Access Compliance Report

Public Rights-of-Way

Intersection ID: 30049	Main Street: SUMMER_COACH_DR	Cross Street: SUNSET_VILLAGE_DR	Location: NW
ADA ID: 5A37515913CC	Ramp Type: Combination1Diag	Initial Pass/Fail: Fail	Overall Compliance: No
		Severity Score: 0

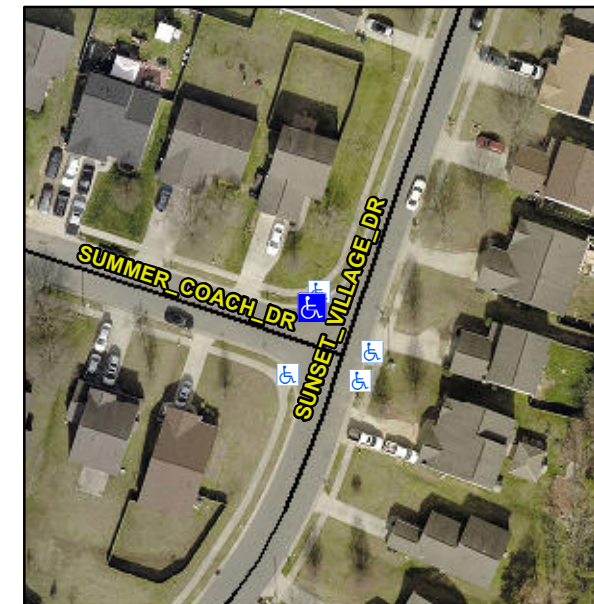
R304.5.1, R304.5.1, R304.2.2, R304.5.3, R304.3.2

Compliance	Description	Data	Compliance	Description	Data
N/A	Ramp Length LT (in)	37.5	N/A	Ramp Length RT (in)	40.0
No	Ramp Width LT (in)	46.5	No	Ramp Width RT (in)	46.0
Yes	Ramp Slope LT (%)	6.2	No	Ramp Slope RT (%)	8.7
No	Ramp XSlope LT (%)	2.5	Yes	Ramp XSlope RT (%)	1.1
N/A	Ramp Length (in)	49.0	No	Ramp Slope (%)	9.2
No	Ramp Width (in)	42.0	No	Ramp XSlope (%)	5.5
N/A	Flare Type LT	N/A	N/A	Flare Type RT	N/A
N/A	Flare Slope LT (%)	N/A	N/A	Flare Slope RT (%)	N/A
N/A	Flare Traversable LT?	N/A	N/A	Flare Traversable RT?	N/A
N/A	Landing Length (in)	N/A	N/A	DWS Provided?	N/A
N/A	Landing Width (in)	N/A	N/A	DWS Contrast?	N/A
N/A	Landing Slope (%)	N/A	N/A	DWS Length (in)	N/A
N/A	Landing X Slope (%)	N/A	N/A	DWS Full Width?	N/A
N/A	Landing Curb? (Y/N)	N/A	N/A	DWS Offset (in)	N/A
N/A	Shared Landing?	N/A			
N/A	Gutter Ponding?	N/A	N/A	Gutter Slope (%)	N/A
N/A	Gutter Lip Ht (in)	N/A	N/A	Gutter X Slope (%)	N/A
N/A	Painted X Walk1?	No	N/A	Painted X Walk2?	No

Remove & Replace Curb Ramp With Two New Directional Ramps or Equivalent.
